## WORKS PROGRESS REPORT for KCTMO GRENFELL TOWER - No 2

| Project Name / Address     | KCTMO Improvements and Enhancements to Grenfell Tower |                          | Ref. 7654       |

(3)

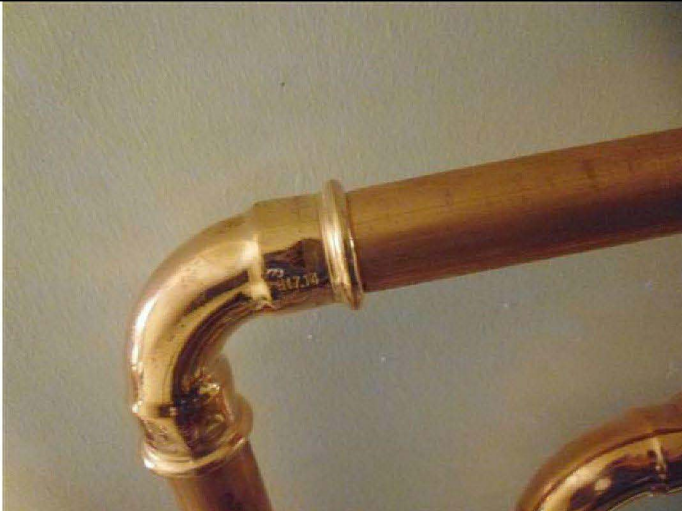
Support brackets are loose on ALL floors

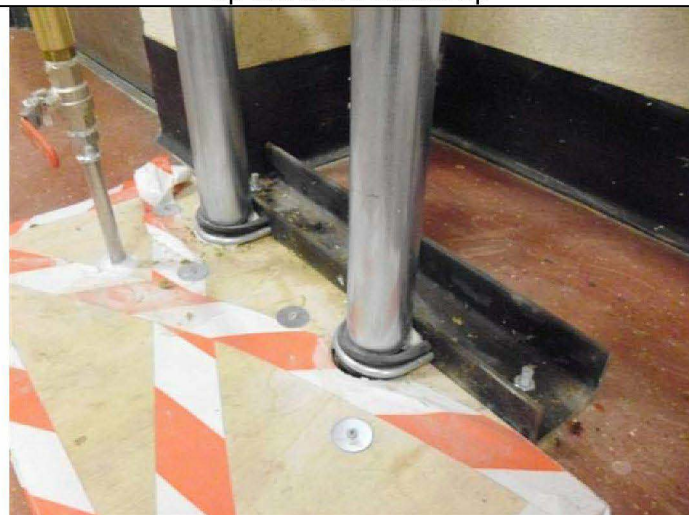
Stool piece fitted for bellows, to be removed after testing
